UNITED STATES PATENT AND TRADEMARK OFFICE

APPLICATION NO.	FILING DATE	FIRST NAMED INVENTOR	ATTORNEY DOCKET NO.	CONFIRMATION NO.
10/802,167	03/17/2004	Michael A. Halter	16990-53331-B	4142

Office Action Summary	Application No. 10/802,167	Applicant(s) HALTER, MICHAEL A.	
	Examiner Seth Barnes	Art Unit 2822

FIG. 7

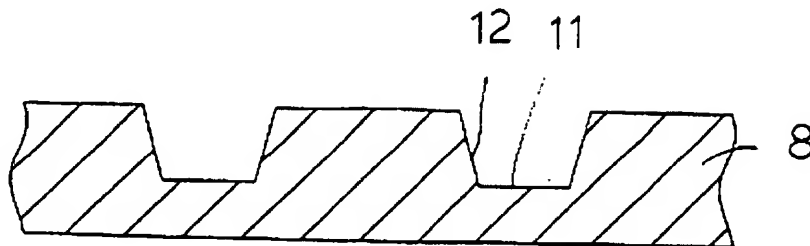
(a) etching the semiconductor wafer to form a micro-reflector cavity (Fig. **7** and col. **4**, lines **41-46**) and

Regarding **claim 12**, Chen discloses in Fig. 7, the method above wherein the step of etching the semiconductor wafer is performed with an etching agent that acts in an anisotropic manner with respect to the semiconductor material (8)

Regarding **claim 15**, Chen discloses in Fig. 7, the method of claim 11, wherein the micro-reflector cavity formed in said etching step is shaped as an inverted, truncated pyramid.

FIG. 11

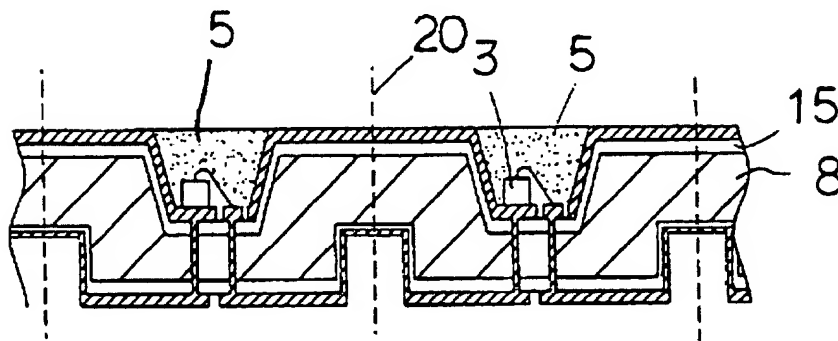
Regarding **claim 11**, Chen discloses in Fig. 11 and col. 5, lines 12-17, the above method further comprising the steps of coating the micro-reflector cavity with a conducting material (16), and connecting the LED to the conducting material.

Regarding **claim 18**, disclose in Fig. 11, the method above wherein said etching step comprises the formation of a plurality of micro-reflector cavities such that the plurality of micro-reflector cavities form a cluster on said wafer.

Regarding **claim 19**, Chen discloses in Fig. 11, the method of claim 12, further comprising the step of encasing the LED die with an encapsulant (5).

Regarding **claim 20**, Chen discloses in Fig. 11, the method of claim 12, wherein said encapsulant is an optical gel (encapsulating resin, col. 5, lines 25-27). It is inherent that the encapsulating resin disclose by Chen has a refractive index and the word high is an ambiguous term.
